The Commission has issued the enclosed Amendments Nos. 147 , 147  
and 144 to Facility Operating Licenses Nos. DPR-38, DPR-47 and DPR-55 for  
the Oconee Nuclear Station, Units Nos. 1, 2 and 3. These amendments consist  
of changes to the Station's common Technical Specifications (TSs) in response  
to your request dated November 19, 1985, as revised on January 14, 1986, and  
February 14, 1986.

These amendments revise the TSs to support the operation of Oconee Unit 1 at  
full rated power during the upcoming Cycle 10. The amendments change the  
following areas: 1) Core Protection Safety Limits (TS 2.1); 2) Protective  
System Maximum Allowable Setpoints (TS 2.3); 3) Rod Position Limits (TS 3.5.2);  
and 4) Power Imbalance Limits (TS 3.5.2). These amendments also make  
administrative changes to clarify the TSs.

DUKE POWER COMPANY  
DOCKET NO. 50-269  
OCONEE NUCLEAR STATION, UNIT NO. 1  
AMENDMENT TO FACILITY OPERATING LICENSE

SAFETY EVALUATION BY THE OFFICE OF NUCLEAR REACTOR REGULATION

Figure 2.1-1

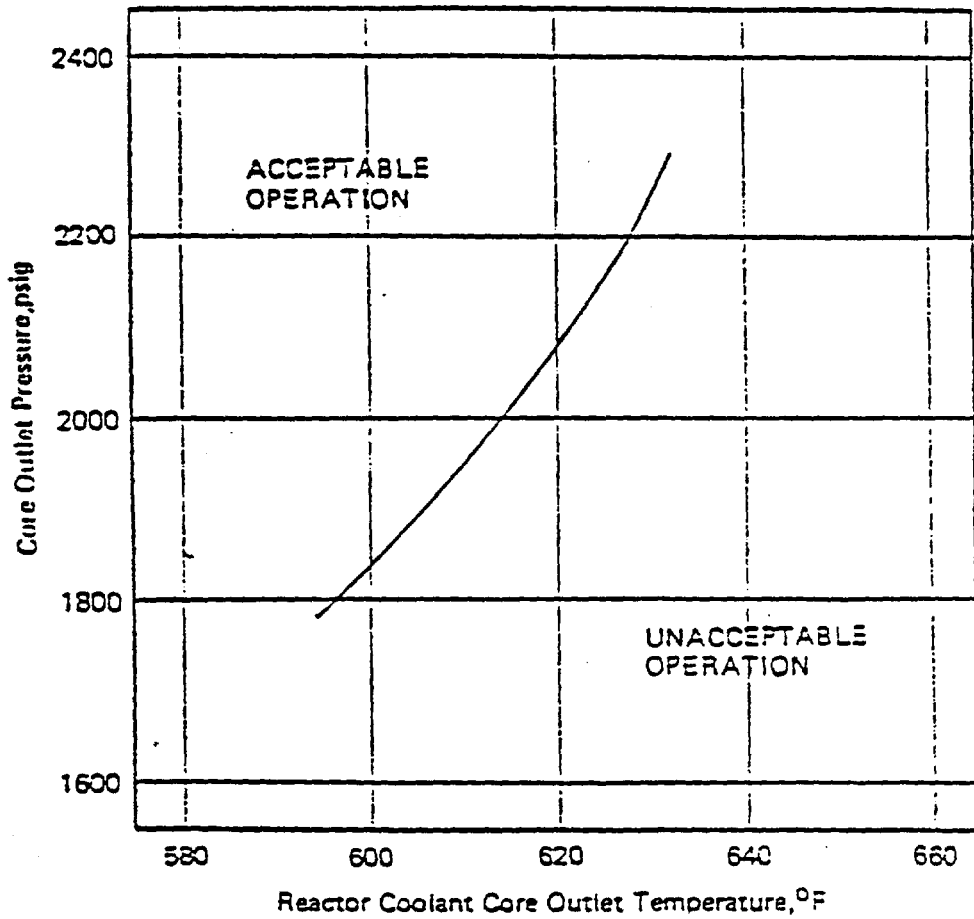
The combination of the reactor system pressure and coolant temperature shall not exceed the safety limit as defined by the locus of points established in Figure 2.1-1. If the actual pressure/temperature point is below and to the right of the line, the safety limit is exceeded.

The curve presented in Figure 2.1-1<sup>(3)</sup> represents the conditions at which the minimum allowable DNBR is predicted to occur for the limiting combination of thermal power and number of operating reactor coolant pumps. This curve is based upon the design nuclear peaking factors which include the potential effects of fuel densification<sup>(4)</sup>:

Figure 2.3-1  
OCONEE NUCLEAR STATION

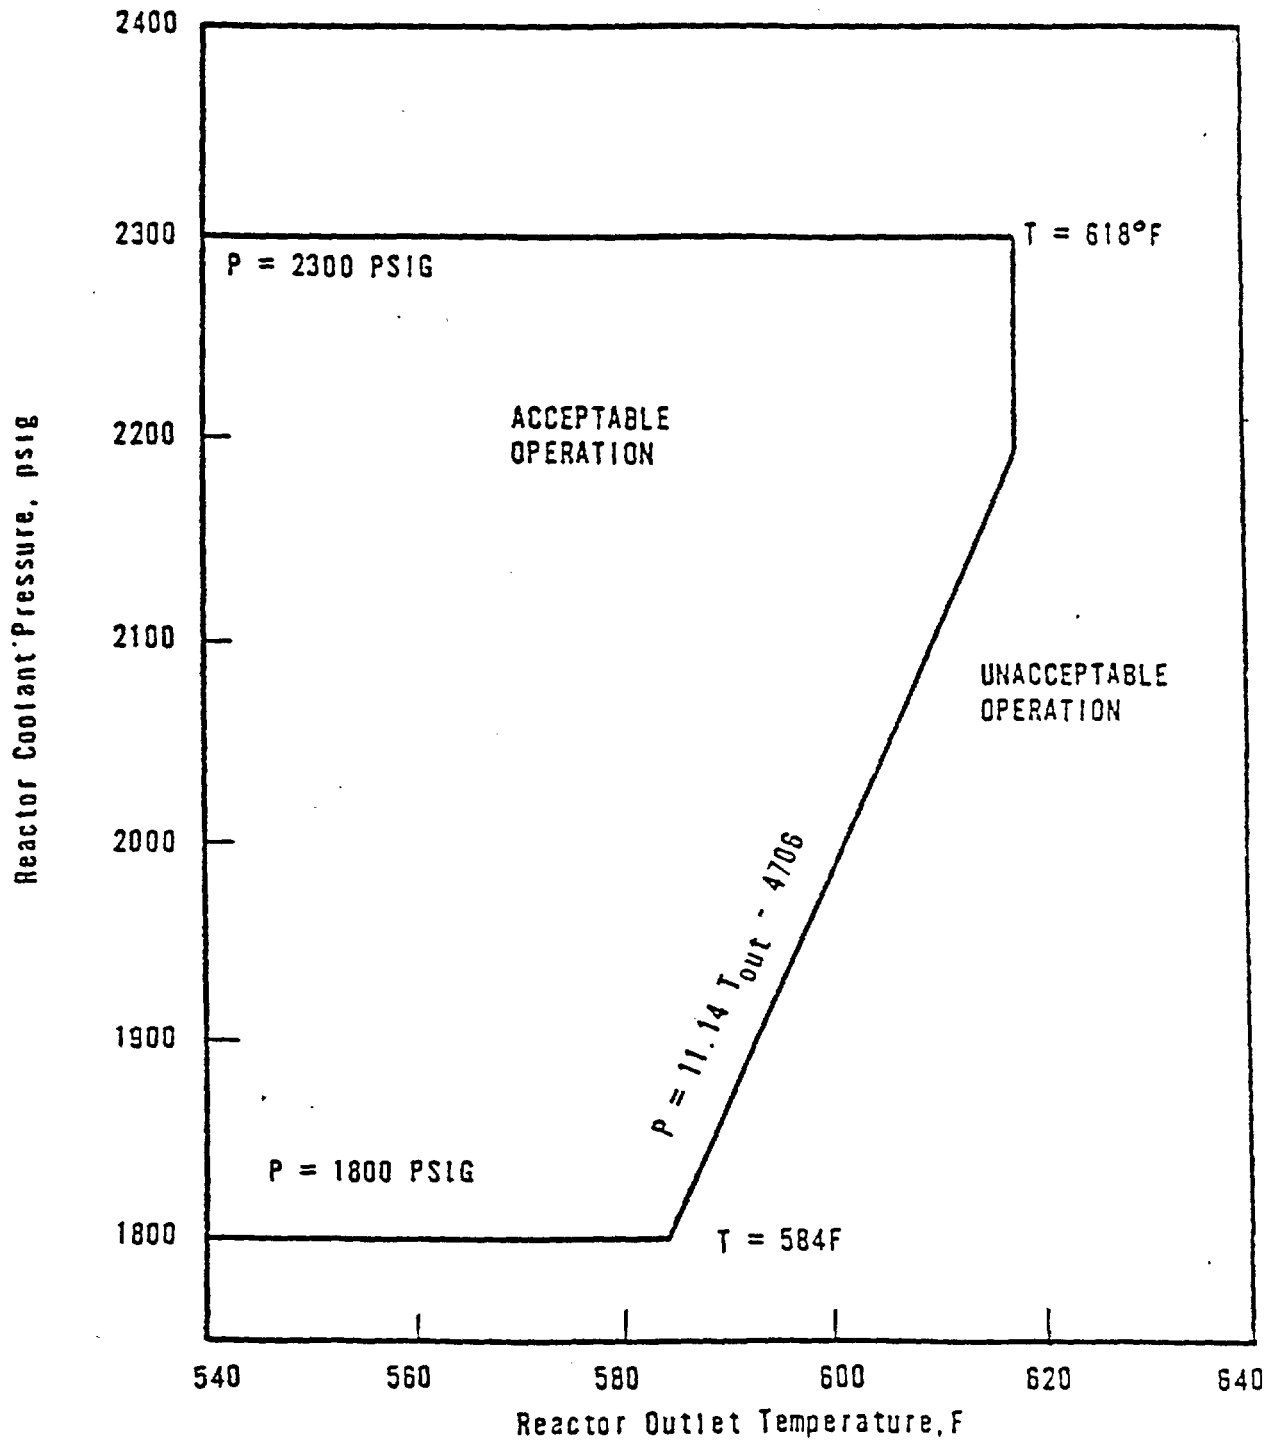
The high reactor coolant outlet temperature trip setpoint (618°F) shown in Figure 2.3-1 has been established to prevent excessive core coolant temperatures. Accounting for calibration and instrumentation errors, the safety analyses used a trip setpoint of 620°F.

Figure 3.5.2-1  
OCONEE NUCLEAR STATION

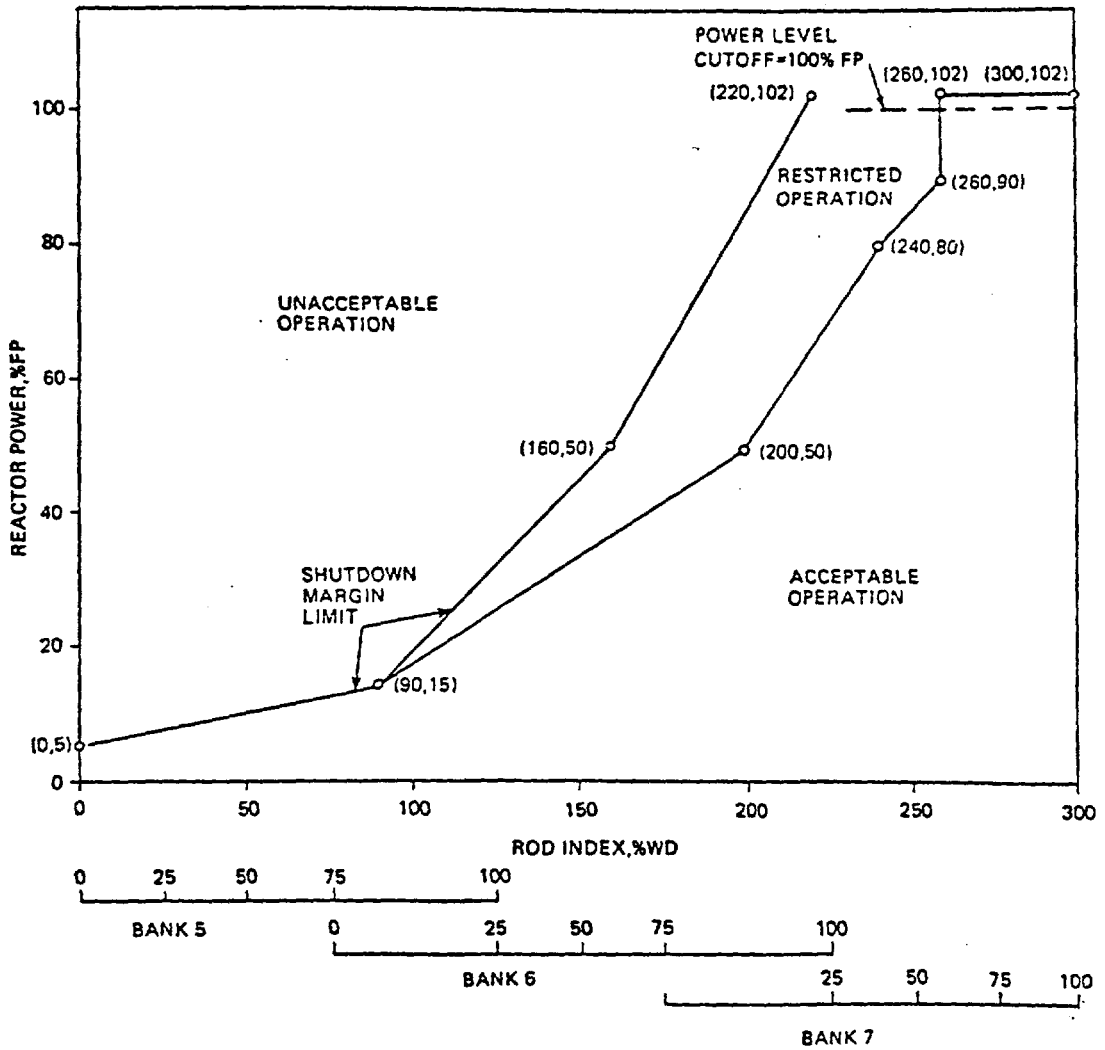
ROD POSITION LIMITS FOR FOUR PUMP OPERATION  
FROM 0 EFPD TO EOC UNIT 1
